Product: 1995 Arctic Cat TigerShark Watercraft Service Repair Workshop Manual

# Bulletins & Newsletters

## 1995 Carburetor Recalibration Specifications

Fig. 1

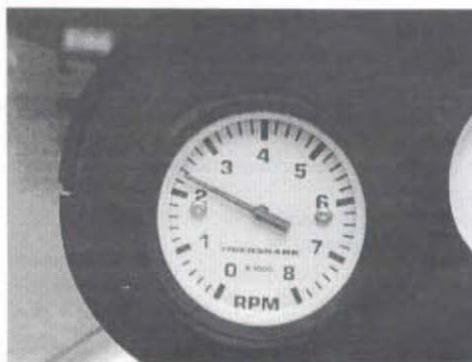
You may have noticed on all 1995 Daytona and 2nd-run Monte Carlo models (serial number ARJ4054A495 and above) a discharge fitting plug (with a 3/16 in. hole in the center) installed in the port-side water outlet discharge fitting. This plug causes most of the discharge water to exit through the muffler, which helps reduce exhaust noise.

This plug must be unscrewed when back-flushing a 1995 Daytona or Monte Carlo in the above serial number range. Operating the watercraft without the plug installed is not recommended because it will alter carburetor calibration.

Fig. 2

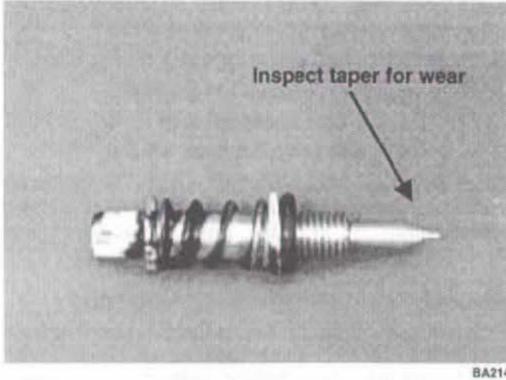
If a Daytona is running at low RPM (i.e., lower than 6800-7200 RPM) at wide-open-throttle in the water, inspect the taper on the fuel screws (see Fig. 2) for damage. Replace the fuel screw(s) if damage is present. A service bulletin addressing this situation will be out shortly.

■ **NOTE:** There should be no step on the taper.

Fig. 3

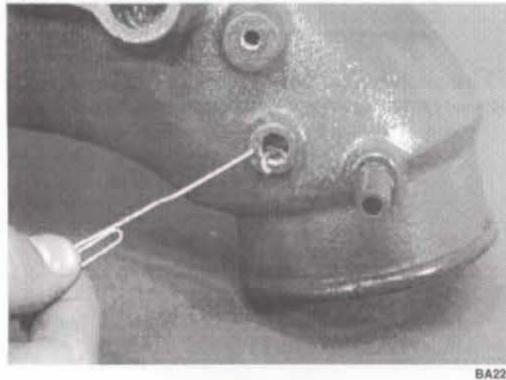
If the model has an aluminum expansion chamber equipped with a cast pipe, inspect the bleed hole for obstructions (see Fig. 3).

Fig. 4

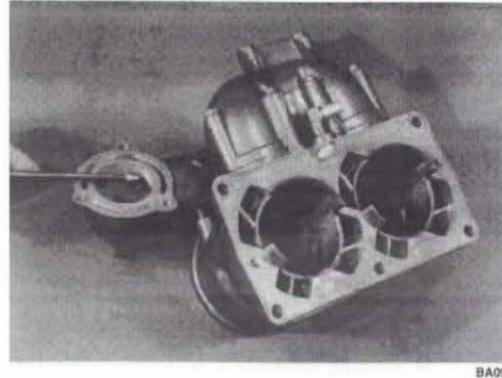
If the model has a stainless steel expansion chamber, inspect the 5 mm exhaust coolant orifice in the exhaust elbow. It must be clean and unobstructed (see Fig. 4).

Fig. 1

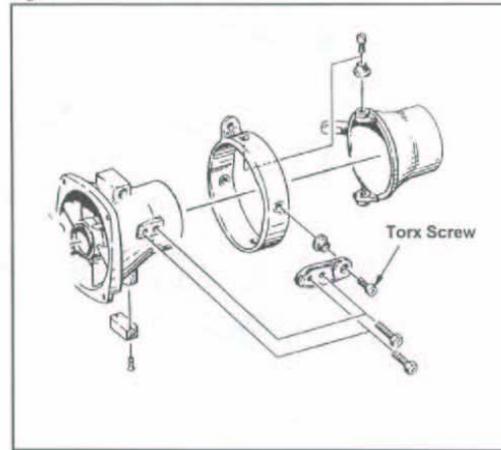
When setting up a 1995 Barracuda or Daytona model, please check that the Torx screws securing the trim bracket to the venturi are properly torqued. Use the following procedure:

1. Using a No. 40 Torx bit, make sure the screws securing the trim bracket to the venturi will withstand 2.6 kg-m (19 ft-lb) of torque.
2. If either Torx screw will not withstand 2.6 kg-m (19 ft-lb) of torque (i.e., the screw either tightens or moves), remove the Torx screw; then apply Green 609 LOCTITE (p/n 0638-289) to the threads of the Torx screw and install. Tighten to 2.6 kg-m (19 ft-lb).

Fig. 2

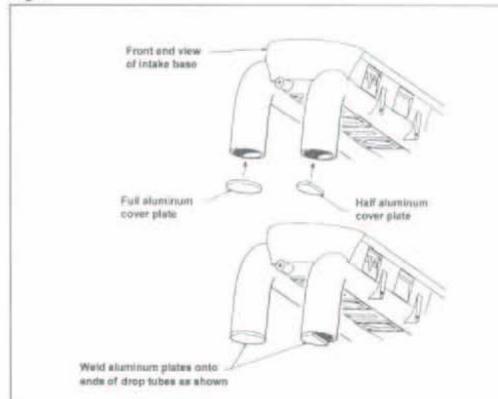
1. If low-end throttle response is less than satisfactory, different carburetor jets and an intake base modification will help if the intake base is stock. If the intake base is not stock or if individual spark arresters have been installed, this procedure will not be beneficial.
2. Remove the existing low-speed jets from all three carburetors and install No. 100 Jets (p/n 6505-786).

3. Remove the existing high-speed jet from the MAG-side carburetor and install a No. 85 Jet (p/n 6505-724).
4. Modify the existing intake base according to the illustration.

■ **NOTE:** Only the front drop tubes must be modified.

Fig. 1

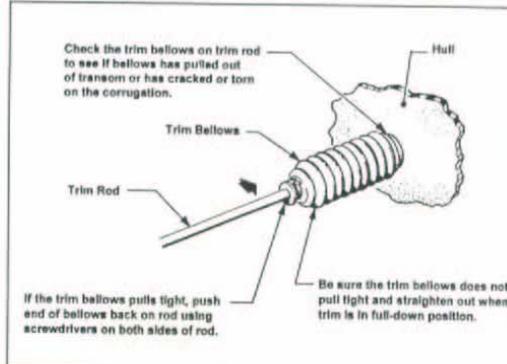
**1996 Trim Bellows (Daytona 770 & Monte Carlo 900)**

Please check all Daytona 770 and Monte Carlo 900 for the possibility of an over-extended bellows at full-down trim or a tear or crack on the corrugation that may have occurred during installation. Please fix or replace as necessary.

Fig. 1

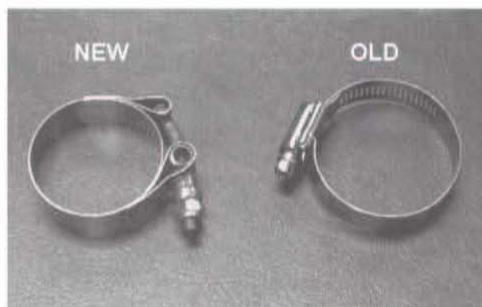
**Solution:** Order sufficient number of Hose Clamp Replacement Kit (p/n 0637-158) for all 1997 Daytona models sold and in stock at your dealership. Replace the existing front floating bearing housing hose clamp with the new clamp from the kit.

■ **NOTE:** The p/n 0637-158 kits have been available for a period of time, and there is a possibility that the updated clamp may already have been installed on a particular 1997 Daytona watercraft. If this is the case, disregard this bulletin for that watercraft. Visually inspect the existing hose clamp and use Fig. 1 to determine the presence of the "old" or "new" clamp.
